2007 South State Street, Seattle, WA

EDG RESPONSE | Priorities & Board Recommenations

COMPOSITE LANDSCAPE PLAN | Landscape Plan

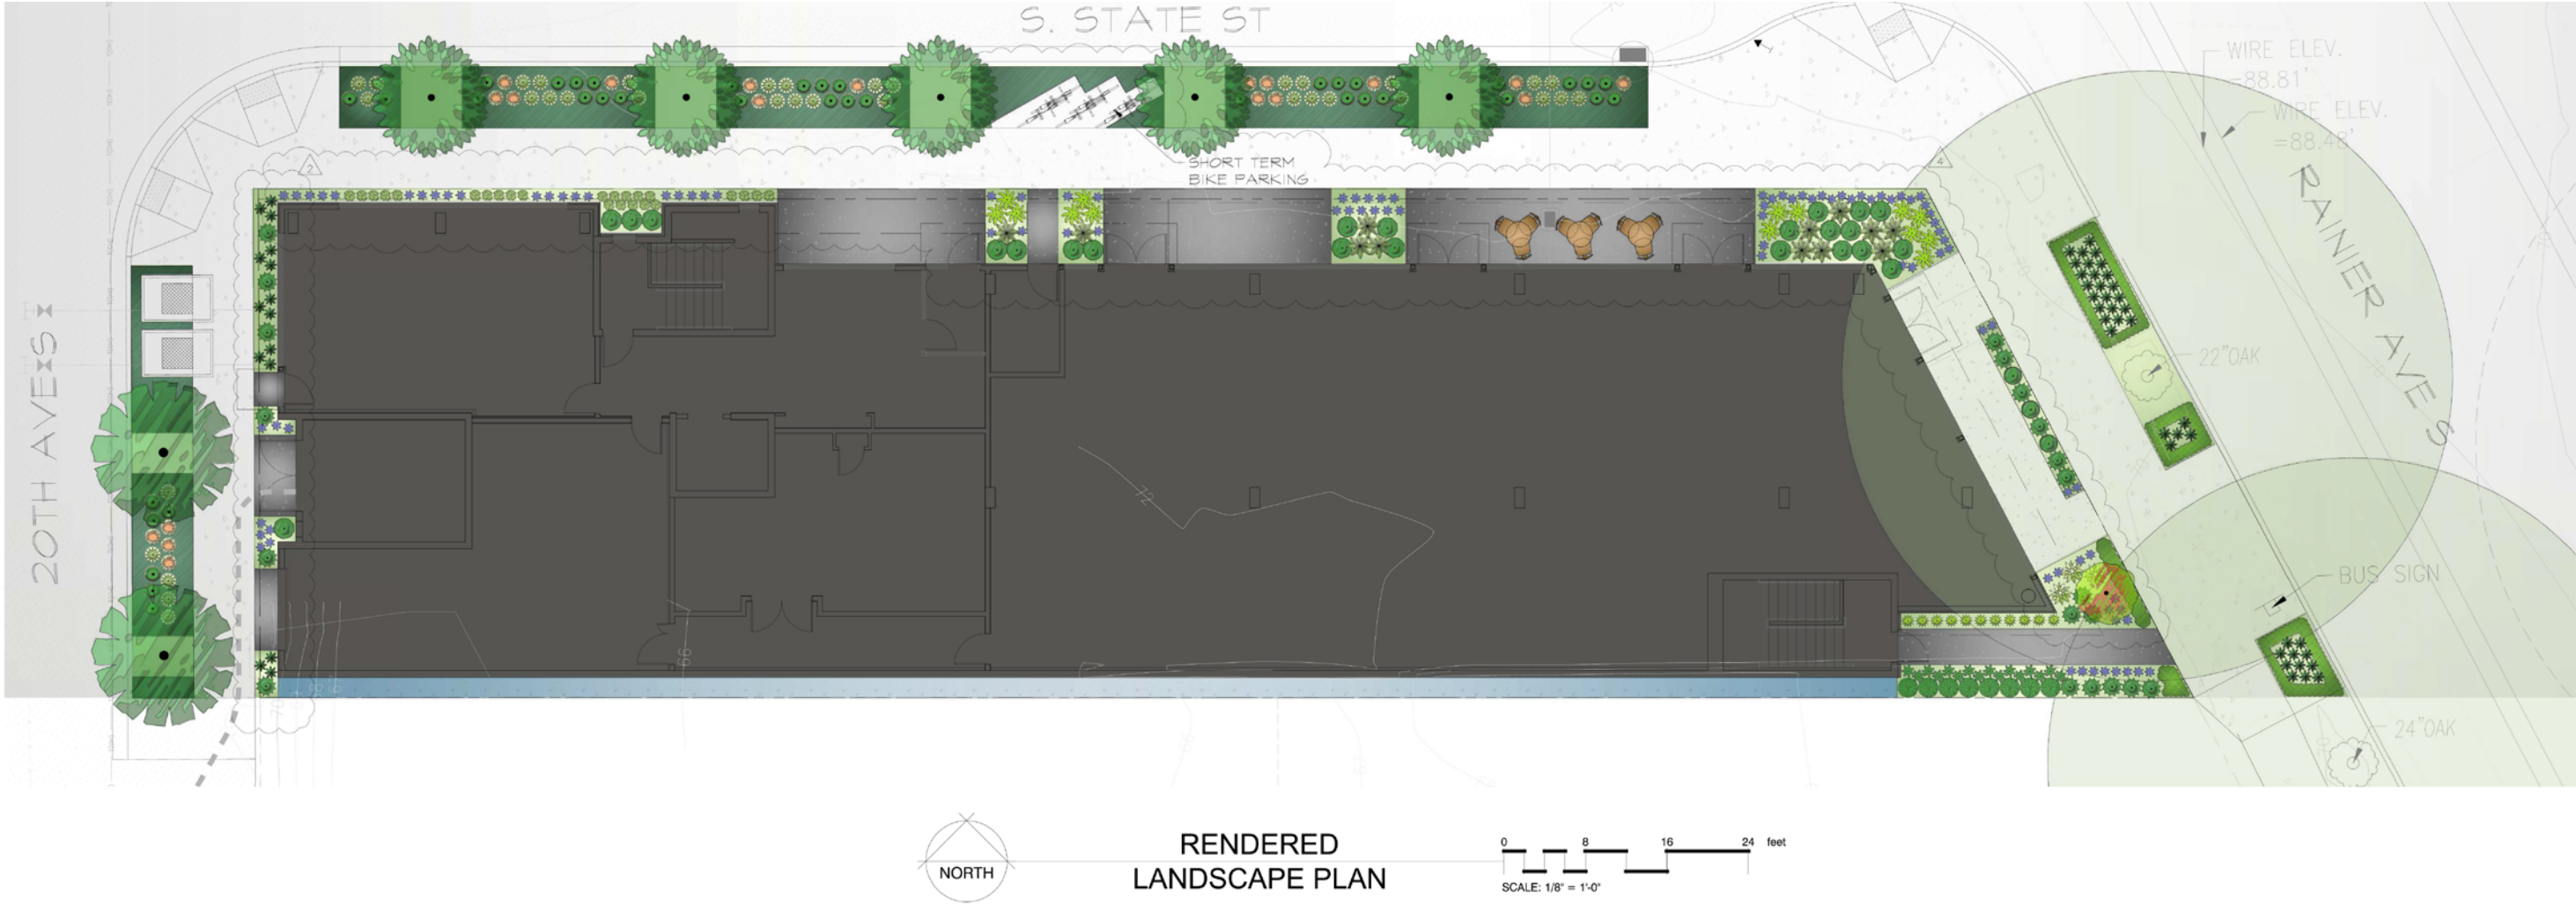
i. The Board offered guidance related to ground level landscaping along Rainier Ave S (PL1) and the impact of existing street trees on the concept of a gateway expression (CS2). Include in the Recommendation packet a landscape plan containing details describing the project’s response to this guidance. The landscape plan should include landscaping at grade and at the roof. (DC4-D)

Rendered landscape plans have been provided for the ground level and roof plans. Per SDOT street standards, the required planting strip and sidewalks will be provided.

SOUTH ELEVATION

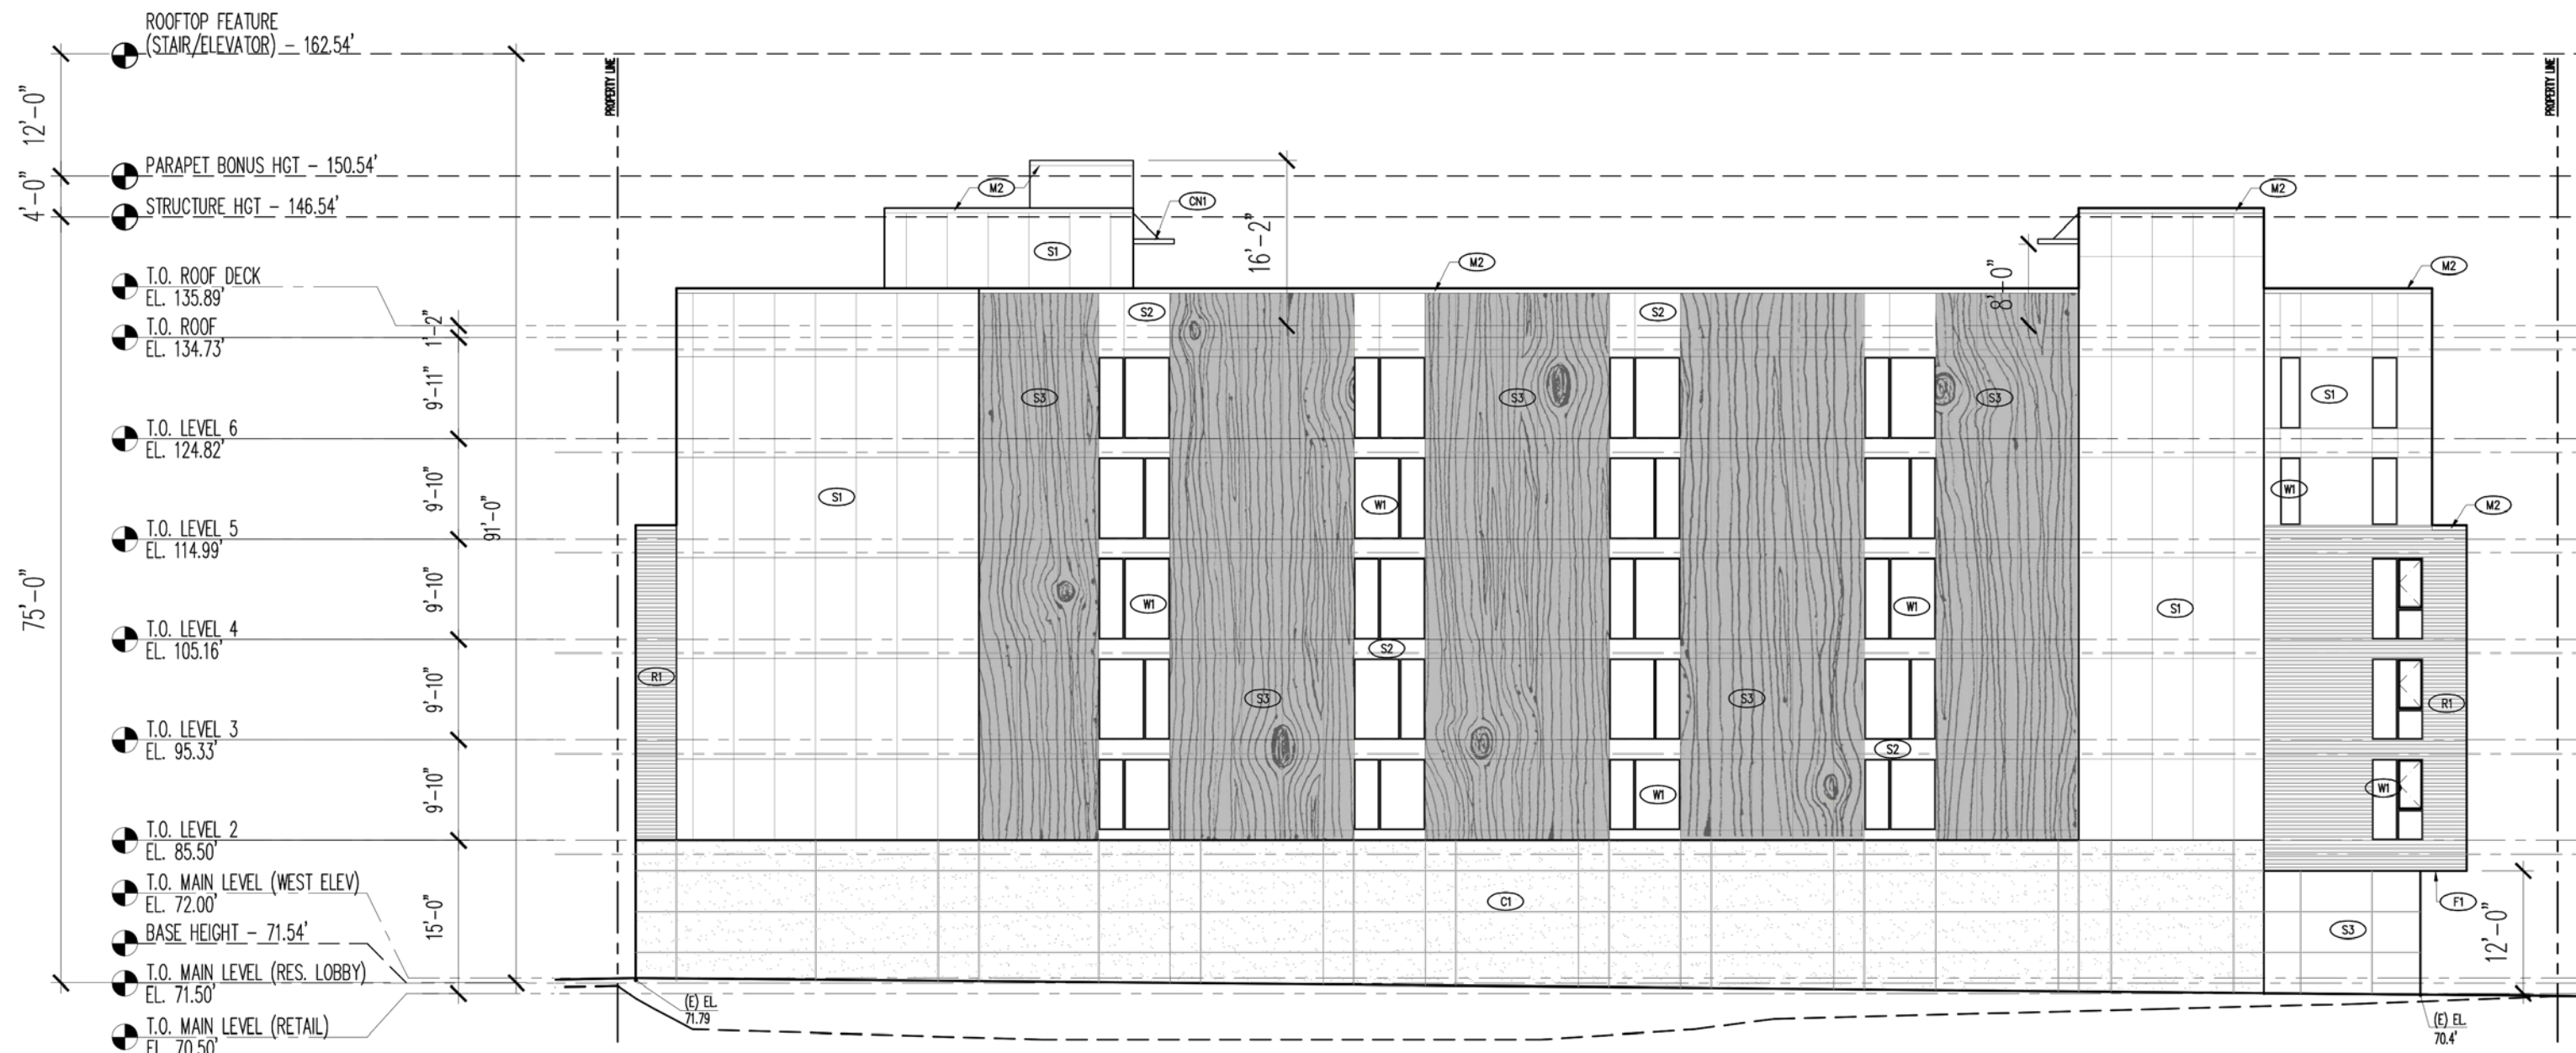
g. The Board agreed the south elevation will be prominent and visible from Rainier Ave S for some time, and therefore recommended treating this inset with glazing. Include in the Recommendation packet information describing the treatment of this façade, including graphics to illustrate how the treatment meets the ground. (DC4-A)

Please see response to item 3.b Design Concept.
The ground or main floor is built to the property line and is concrete. No openings are allowed per building code. The ground floor backs to Stewart Lumber and specifically the Stewart Lumber Yard. Building materials are stacked adjacent to the south property line and the ground floor façade is not visible.
As the upper floor façade is visible and may be for some time mural options are provided. Options 1-4 are simple graphics, Option 5 a wood pattern in reference to Stewart Lumber and Option 6 a plaid pattern to add color and interest.

Recommendation Meeting Response:
Reveals are indicated at the main level concrete façade and are coordinated with the fenestration and panels above.

WEST ELEVATION

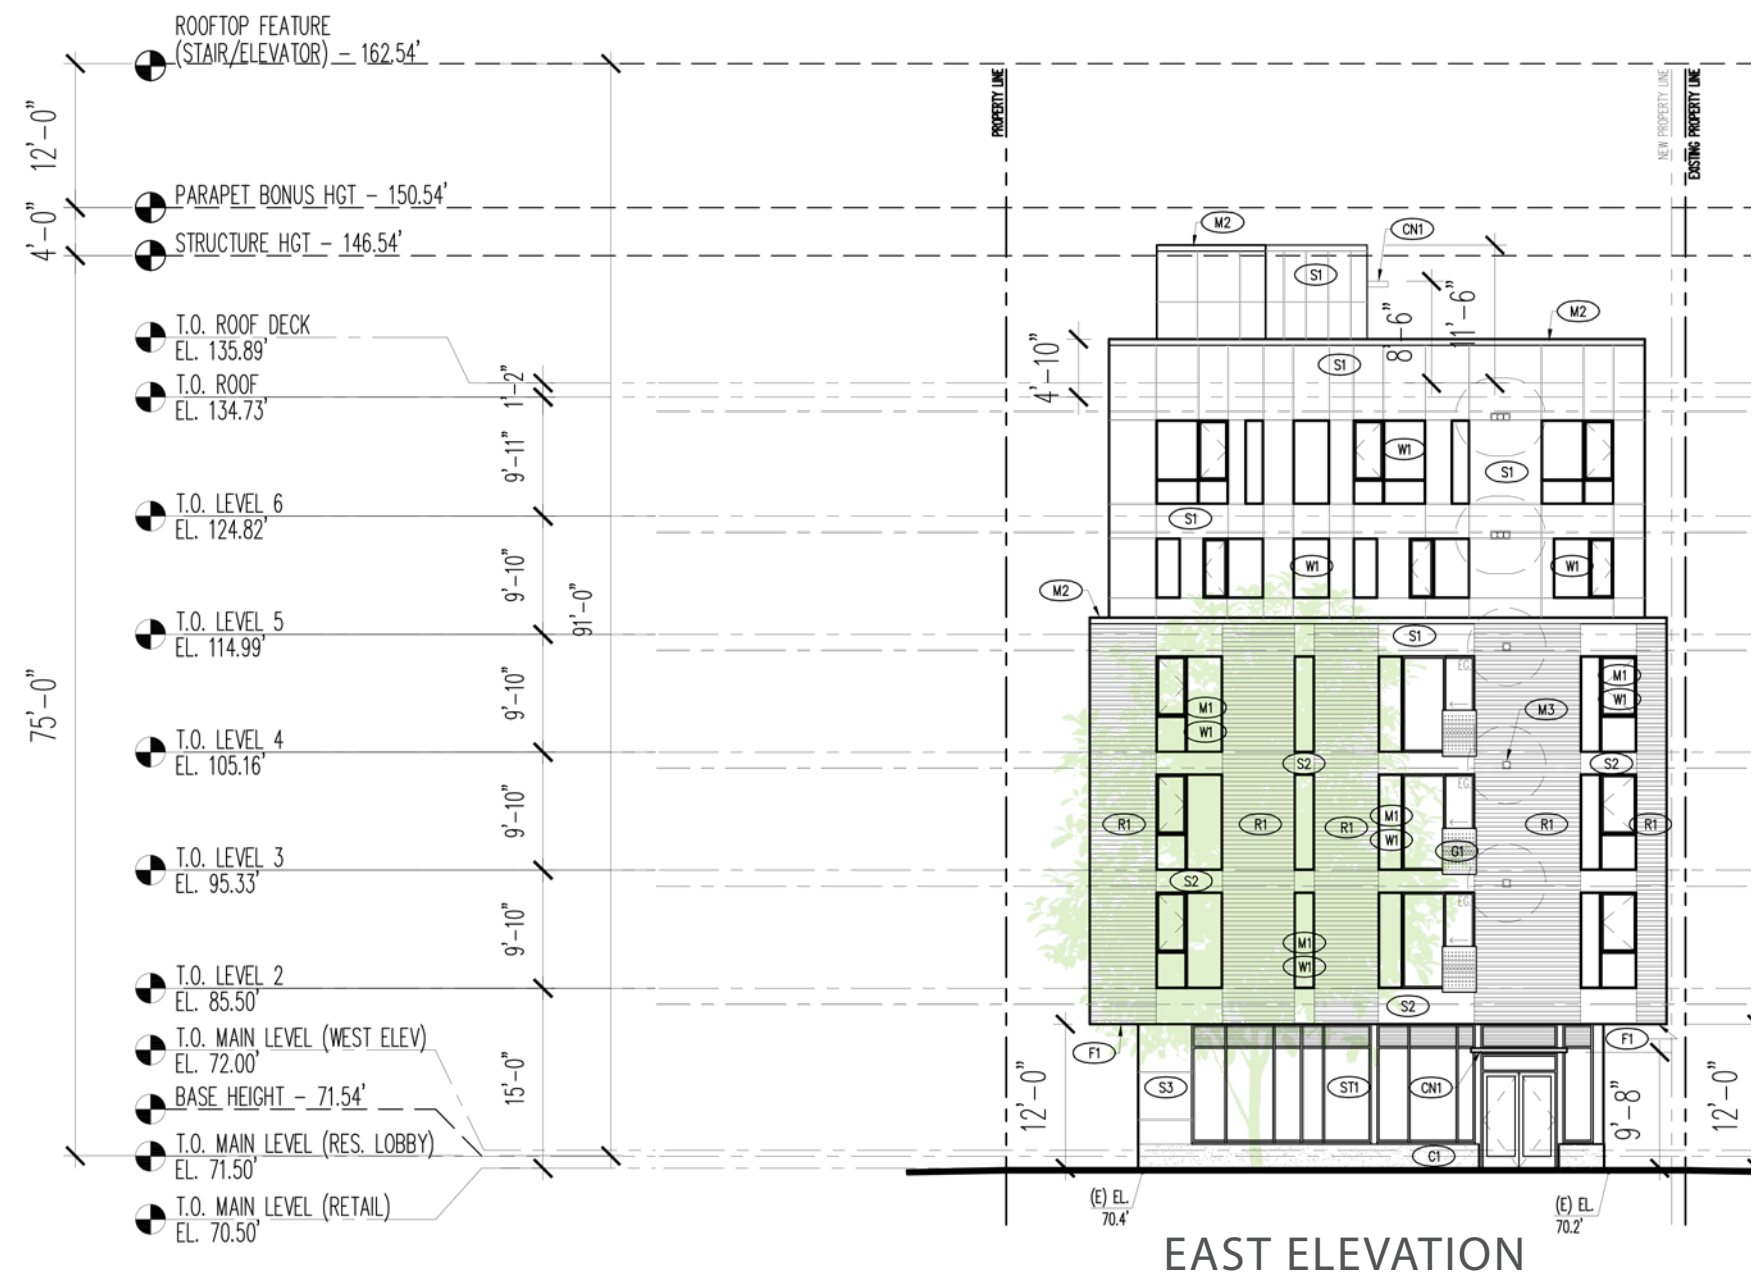
d. In consideration of the zone transition and recommended residential character of the northwest corner of the building, the Board noted that Juliet balconies and glazing details could add depth and texture to the facades and encourage an active street life. Include in the Recommendation packet details describing proposed secondary architectural features. (DC2-C)

The addition of Juliet balconies has been provided at the west facade. The balcony guards are made of a perforated metal sheet that will add a level of interest to the wood facade.

Recommendation Meeting Response:
The fenestration perimeter “jambs” at main through level 4 have been further extended to accentuate the depth relative to the siding.

NORTH ELEVATION - OPT 1

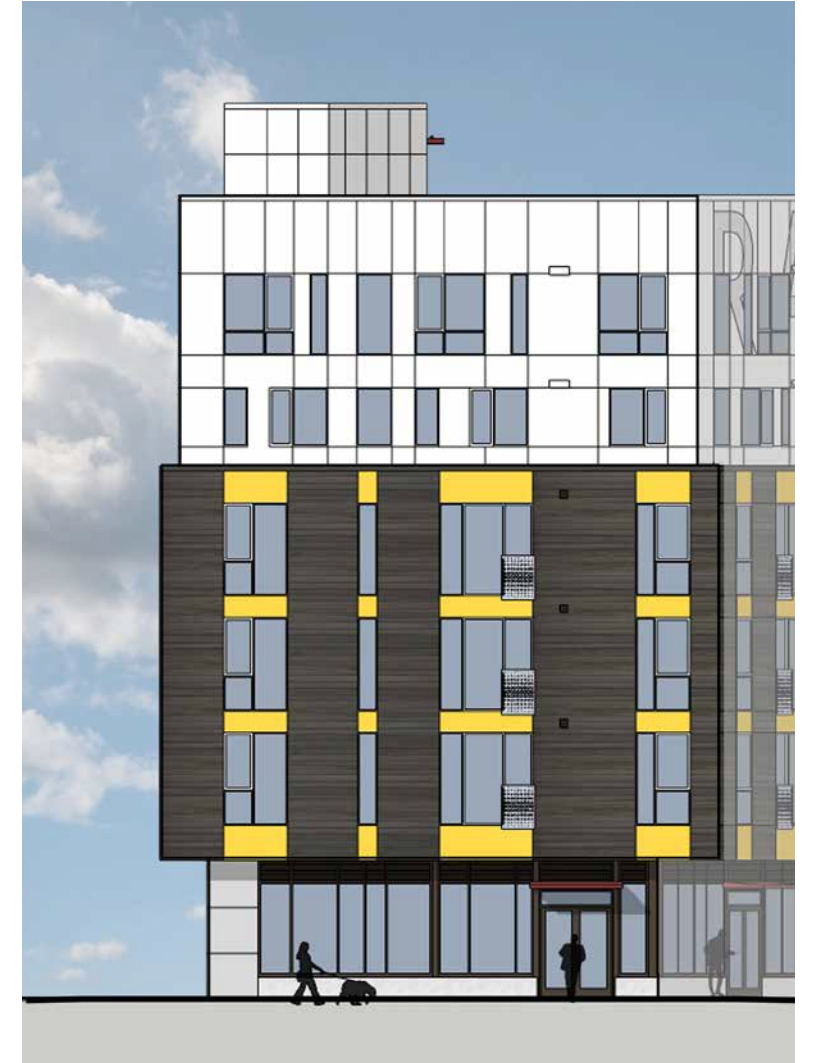
f. As noted in guidance for CS2-C above, the Board requested further development of the gateway concept, noting that materiality is one strategy that could further express this concept. The Board recommended a change in glazing or material at this northeast corner to successfully articulate the gateway concept. (DC4-A)

Option 1 is the preferred concept. The building is now considerably hidden by the construction of the new Hamlin School across State St., limiting the visibility of the building from Rainier Ave S. To compensate for this new condition, elements on the facades were revised to enhance the building as viewed along Rainier Ave S., In addition, components on all façades have been coordinated to provide design cohesion.

The façade modulation at the north and east elevations between levels 2-4 cantilever and upper story setback is clearly defined by material differentiation. The different materials accentuate the cantilever, distinguish it from the stories above and the main floor below, and provide more material and color interest at the intersection. The vertical wood panels extend the entire cantilever. The panels above and below the fenestration have been changed to yellow. Juliet balconies used on the west façade are also used on the north and east levels 2-4 cantilever.

Large lettering "RAINIER" is proposed on the north facade. The signage is off-grey, diffuse, and subtle. It is unlikely this signage will be visible to vehicular traffic as the Hamlin School hides the north facade. However, it is designed to provide relief to the white façade and indicate the entry to Rainier Valley. The sign will be visible to pedestrians, specifically the numerous multi-family buildings under construction to the east.

SOUTH ELEVATION - MURAL OPT 1 (PREFERRED)

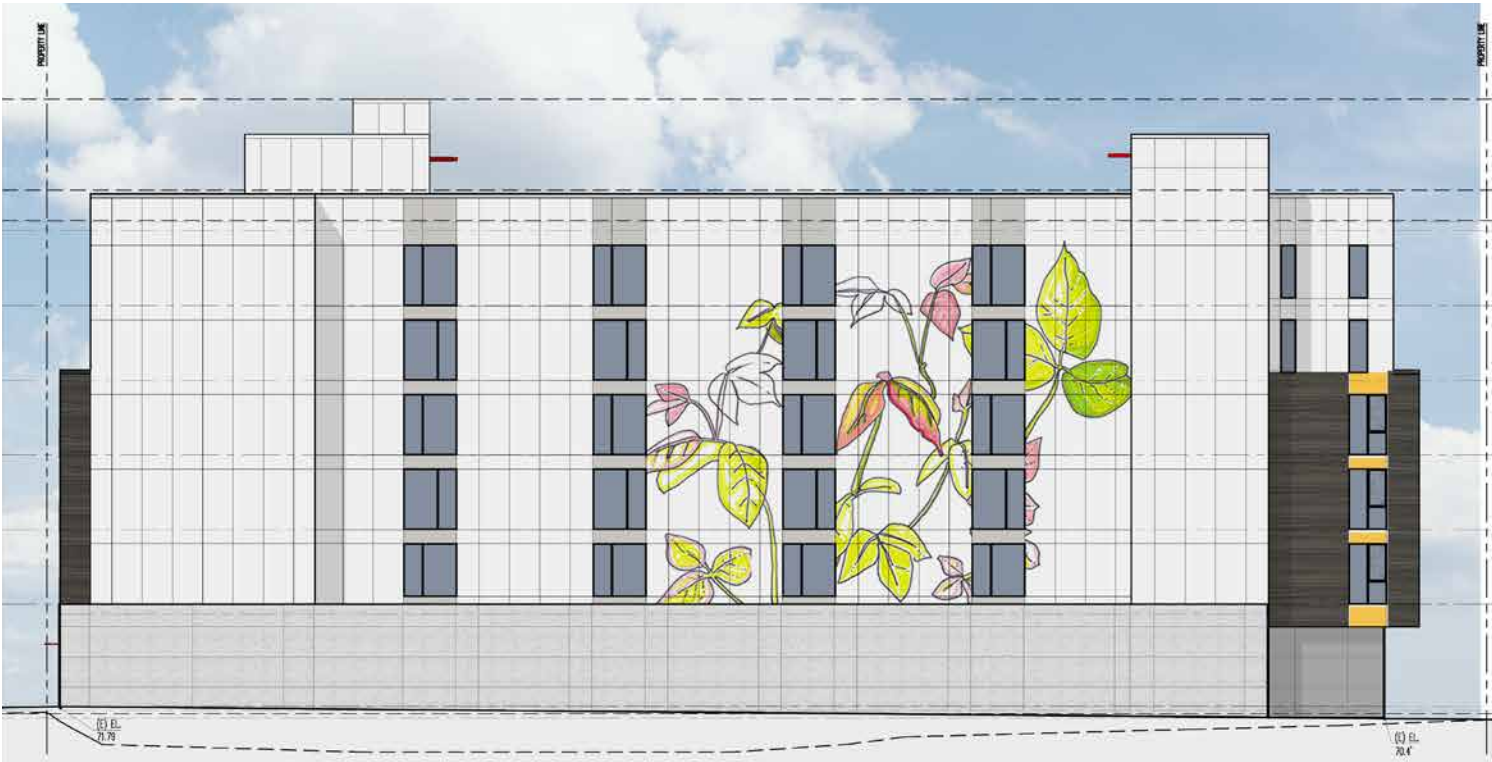
b. The preferred Option 1’s inset at the south elevation offered opportunity for natural ventilation (as described in the guidance for CS1-B above), as well as an opportunity for the application of glazing. Ensure this south elevation is carefully designed, considering the composition and architectural expression of the building as a whole as this south elevation will be visible for some time. See additional guidance below under DC4. (DC2-B)

Ventilation can not be provided due to the fire separation distance to the south property line. Also due to the fire separation distance, glazing has been provided at near maximum allowable capacity. Several mural options have been provided as ways to address the large facade’s visibility.

Recommendation Meeting Response:
Four mural options are provided. See response to 3.g for south elevation facade images.

The wood grain is preferred as it clearly highlights and delineates the recessed façade between the two stairwells. The wood grain provides neighborhood context to the well-known Stewart Lumber Yard and Building directly to the south. Stewart Lumber has been in this location since 1926, and the structure is well known throughout Rainier Valley.

The background is shaded grey with the wood grain linework in black to accentuate the graphic. The panels above and below the fenestrations are painted yellow to coordinate with the panel color on the north and east façades.
